From: Bill Goodenough <BGoodenough@ecww.org>
Subject: St. James estimates
Date: September 20, 2011 5:52:17 PM PDT
To: Terry Kylo <terry@terrykylo.com>
Cc: Joan Anthony <JAnthony@ecww.org>, Greg Rickel <GRickel@ecww.org>

RE: **St James, Sedro Woolley
Structural Repairs**

**STRUCTURAL EVALUATION FOR
ST. JAMES EPISCOPAL CHURCH
SEDRO-WOOLLEY, WA**

(A) DETAIL
 1" = 11'-0"

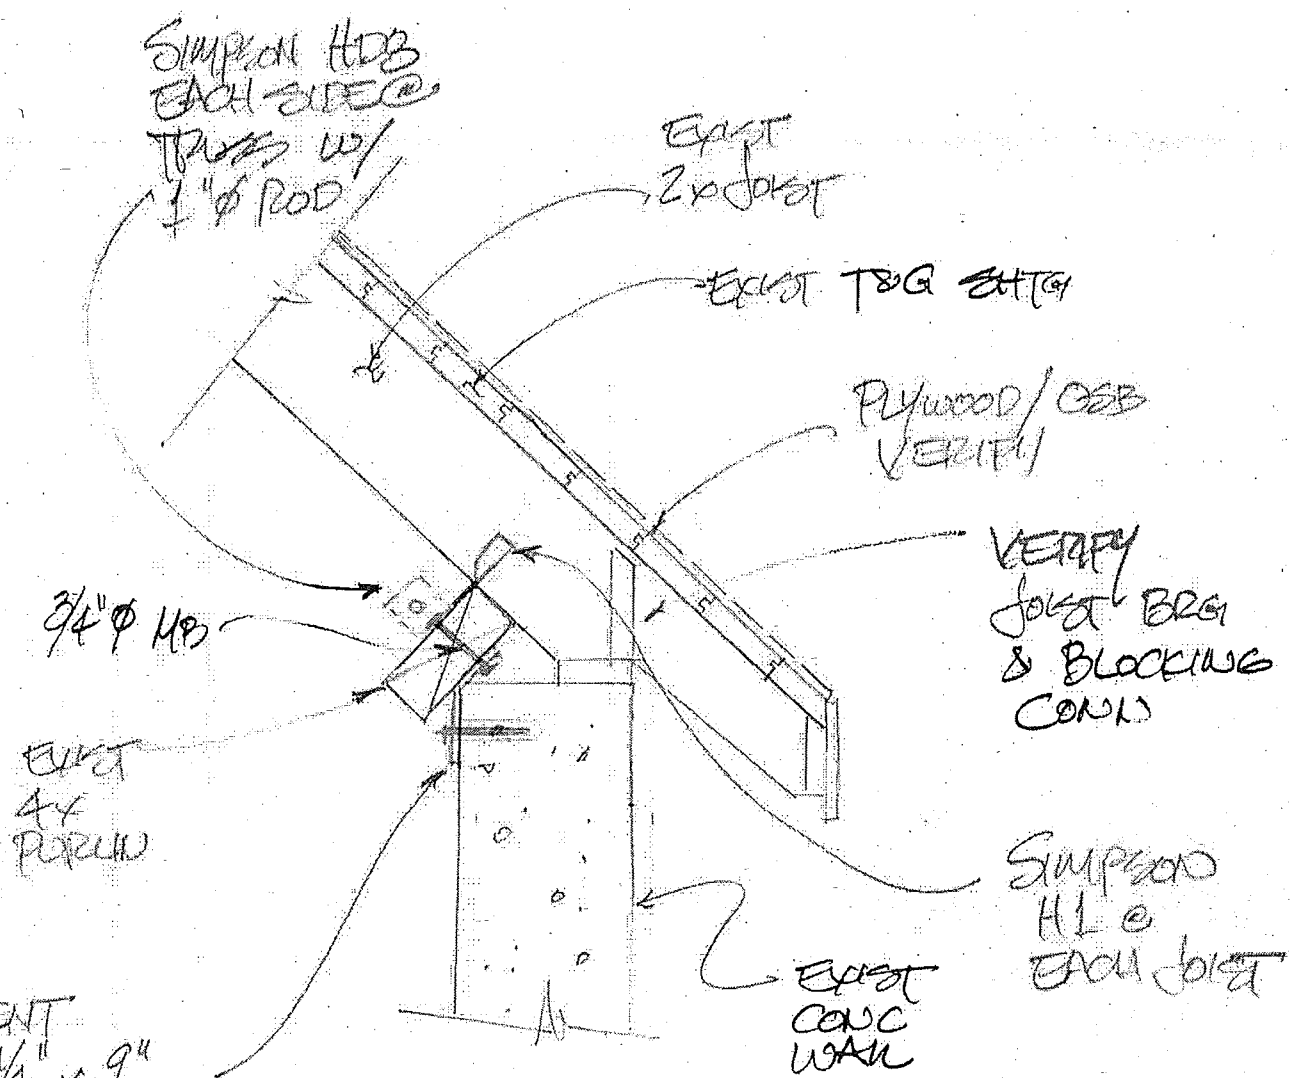
August 18, 2011 – Rick Oehmcke of PCS was OK with the proposed design – see detail A attached.
September 20, 2011 – Chad checked his steel quote. Was concerned about the bell tower steel framing that will require more detail and we need to add cushion.

I would like to review the logistics of detail "A" prior to construction as I am not sure that this detail can actually be constructed as drawn. In order to get the bolts thru the 4x member I have assumed the 4x member would need to be removed and re-installed. A bit of brainstorming would be helpful in this to see if we could come up with an alternate detail to avoid a lot of electrical removal and re-install.
